Loon Lake Class II Inspection Ground Water, Permit No. ST 8019

A Class II inspection was conducted at the Loon Lake Wastewater Treatment Plant August 23-25, 1994. The inspection consisted of two parts: 1) an engineering evaluation of the effectiveness of treatment, and 2) an evaluation of the ground water monitoring program. This document describes the methods and findings of the ground water evaluation.

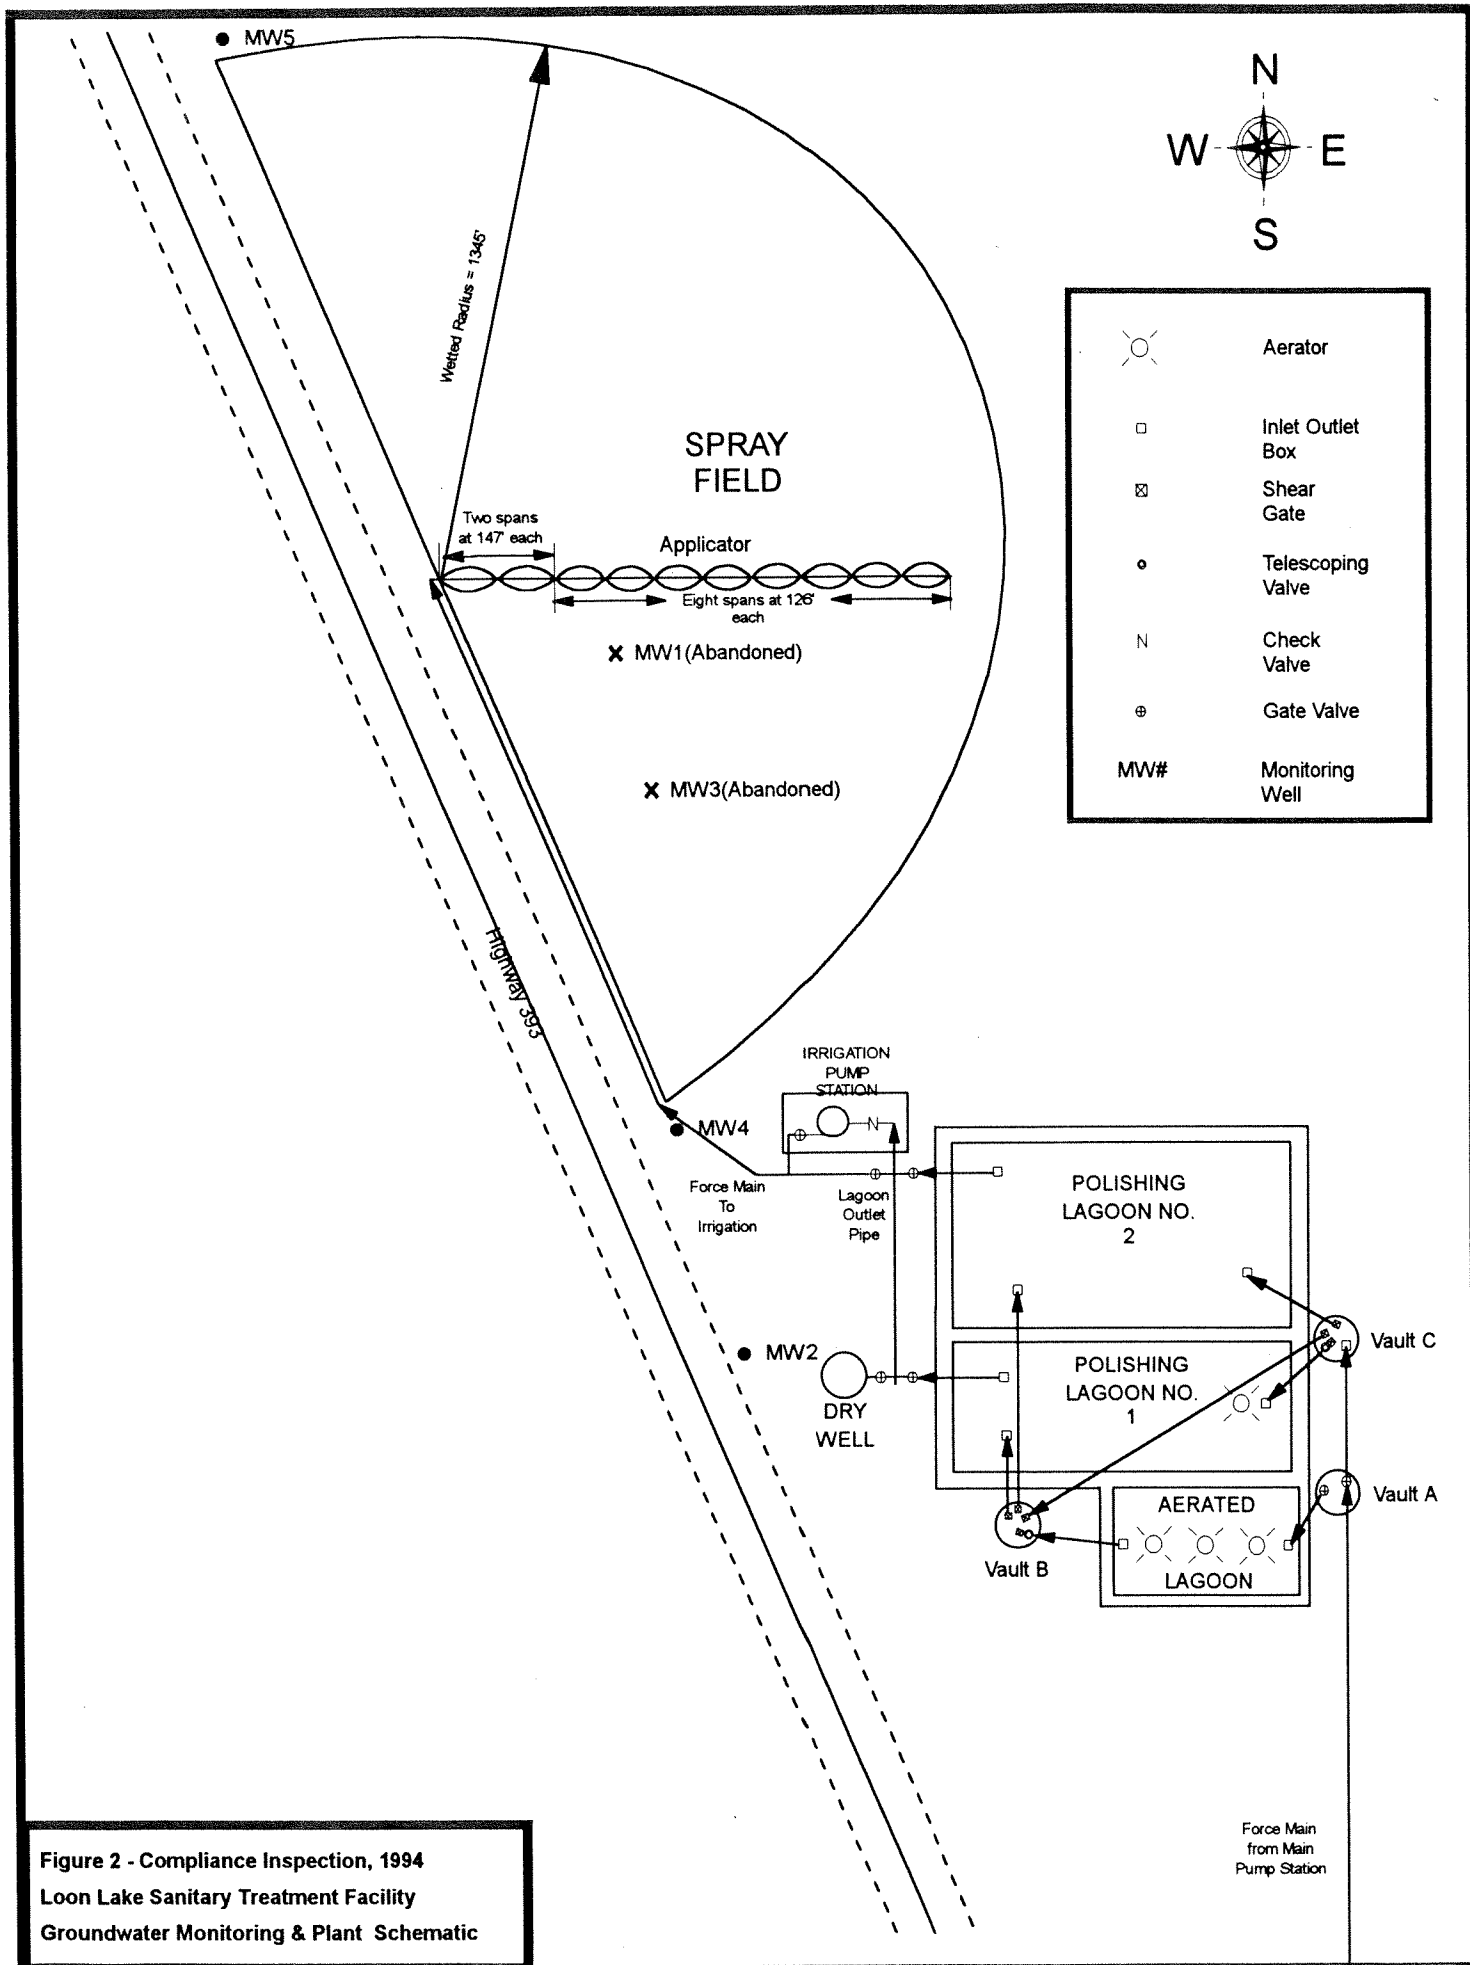
Ground water monitoring has been conducted at the facility since 1985. The ground water monitoring network consists of three wells (MW2, MW4, and MW5). The locations of the wells are shown in Figure 2. MW5 is intended to be an upgradient well, and MW2 and MW4 are intended to be downgradient wells. Two monitoring wells located within the land application area (MW1 and MW3), were decommissioned in 1986 at the request of Ecology.

The ground water flow direction must be known to evaluate the adequacy of the well placement. It is not possible with the existing monitoring well configuration to verify the ground water flow direction. Wells are located along a single line which does not allow for triangulation of water-level elevations. Initially, when the monitoring wells were installed, the ground water flow direction was assumed to be to the south or southwest. In my opinion, the ground water flow beneath the site may have a westerly component. Information that supports this view are:

If there is a westerly component to ground water flow, MW2 and MW4 may not be located downgradient of the spray field. Also, MW5 is located so close to the spray field that an accurate ground water flow direction must be determined to ensure that MW5 is unaffected by the facility.

1. The ground water flow direction must be defined at the spray field. Only with an understanding of the ground water flow direction is it possible to evaluate the adequacy of the monitoring network. The ground water flow direction probably can be defined by using water level elevations from monitoring wells and vicinity private wells measured about the same time. Based on a consultant's well survey (Century West Engineering Corporation, 1985) a sufficient number of private wells may exist in the area to define the ground water flow direction. However, private wells should only be included in the water-level monitoring network if the well construction is known and the well is screened in the uppermost aquifer.

2. If the ground water flow direction can be defined with the existing private and monitoring wells, the monitoring network should be evaluated to determine if additional wells are needed. At least one well should be upgradient of the spray field to provide samples of the upgradient water quality. A sufficient number of wells, usually three or four, should be downgradient of the spray field to detect contamination. All new wells should meet the requirements of Minimum Standards for Construction and Maintenance of Wells (Chapter 173-160 WAC).
